Change Request for Diablo Canyon UFSAR Section 2.5¹

UFSAR Change Request**1. UFSAR AFFECTED CONTENT:**

Living UFSAR to be Changed (check only one): <input checked="" type="checkbox"/> Living DCP UFSAR or <input type="checkbox"/> Living DC ISFSI UFSAR	
Section(s): 2.5 (Seismology and Geology)	
Table(s): N/A	Figure(s): 2.5-33, 2.5-34, 2.5-35, 2.5-36

FSAR UPDATE
UNITS 1 AND 2 DIABLO CANYON SITE
FIGURE 2.6-33 FREE FIELD SPECTRUM HORIZONTAL 1991 LTSP (84TH PERCENTILE NON- EXCEEDANCE) AS MODIFIED PER SSER 34

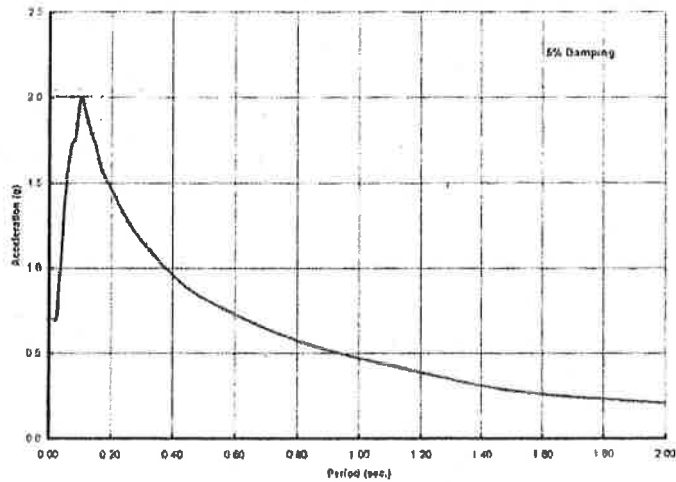
36	N/A	N/A	2.5-33	N/A	Added Figure 2.5-33 Fire Field Spectra Horizontal 1991 LTSP as Modified per SSER 34	N/A	SSER 34	N/A	N/A	N/A	LBVP Enhancement to add a figure in support of enhancements to the body of section 2.5.3.10.4.	N/A	This figure is based on Figure 2.4 SSER 34. Calculation 72.2.7 details the alteration from being a frequency based plot to a period based plot. This figure is used as support for material added in AD Matrix Item # 24. These enhancements are derived from correspondence with the NRC, NRC regulatory documentation, and specific UFSAR text; therefore, a 10 CFR 50.59 Screen is not required.	No
37	N/A	N/A	2.5-34	N/A	Added Figure 2.5-34 Fire Field Spectra Vertical 1991 LTSP as Modified per SSER 34	N/A	SSER 34	N/A	N/A	N/A	LBVP Enhancement to add a figure in support of enhancements to the body of section 2.5.3.10.4.	N/A	This figure is based on Figure 2.5 SSER 34. Calculation 72.2.7 details the alteration from being a frequency based plot to a period based plot. This figure is used as support for material added in AD Matrix Item # 24. These enhancements are derived from correspondence with the NRC, NRC regulatory documentation, and specific UFSAR text; therefore, a 10 CFR 50.59 Screen is not required.	No

FSAR UPDATE
UNITS 1 AND 2 DIABLO CANYON SITE
FIGURE 2.5-35 FREE FIELD SPECTRA - HORIZONTAL LTSP (PG&E 1988) GROUND MOTION VS HOSGRI (NEWMARK 1977)

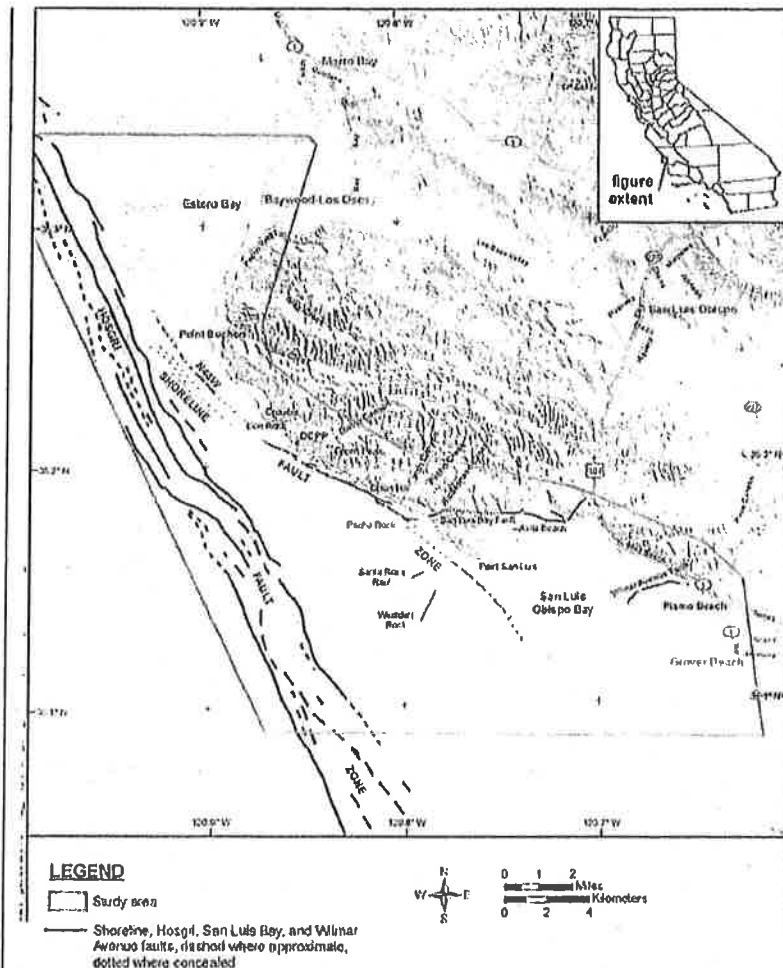
Figure 2.5-35 shows a comparison of the horizontal 1991 LTSP response spectrum with the 1977 Newmark Hosgri spectrum (based on Reference 40, Figure 7-2). This comparison indicates that the 1977 Hosgri spectrum is greater than the 1991 LTSP spectrum at all frequencies less than about 15 Hz, but the 1991 LTSP spectrum exceeds the 1977 Hosgri spectrum by approximately 10 percent for frequencies above 15 Hz. This exceedance was accepted by the NRC in SSER 34 (Reference 42), Section 3.8.1.1 (Ground-Motion Input for Deterministic Evaluations):

38	N/A	N/A	2.5-35	N/A	Added Figure 2.5-35 Fire Field Spectra - Horizontal LTSP (FGE 1988) Ground Motion vs. Height (Newmark 1977)	N/A	N/A	N/A	N/A	N/A	LBVP Enhancement to add a figure in support of enhancements to the body of section 2.5.3.10.4.	N/A	This figure is based on Figure 7-2 of the Final Report of the Diablo Canyon Long Term Seismic Program, July 1988, adjusted as stated in SSER 34. This figure is used as support for material added in AD Matrix Item # 24. These enhancements are derived from correspondence with the NRC, NRC regulatory documentation, and specific UFSAR text; therefore, a 10 CFR 50.59 Screen is not required.	No
39	N/A	N/A	2.5-36	N/A	Added Figure 2.5-36 Map of Shoreline Fault Study Area	N/A	N/A	N/A	N/A	N/A	LBVP Enhancement to add a figure in support of enhancements to the body of section 2.5.7.1.	N/A	This figure is based on Figure 1-1 of the Report on the Analysis of the Shoreline Fault Zone - Central Coastal California, January 2011. This figure is used as support for material added in AD Matrix Item #29. These enhancements are derived from correspondence with the NRC, NRC regulatory documentation, and specific UFSAR text; therefore, a 10 CFR 50.59 Screen is not required.	No
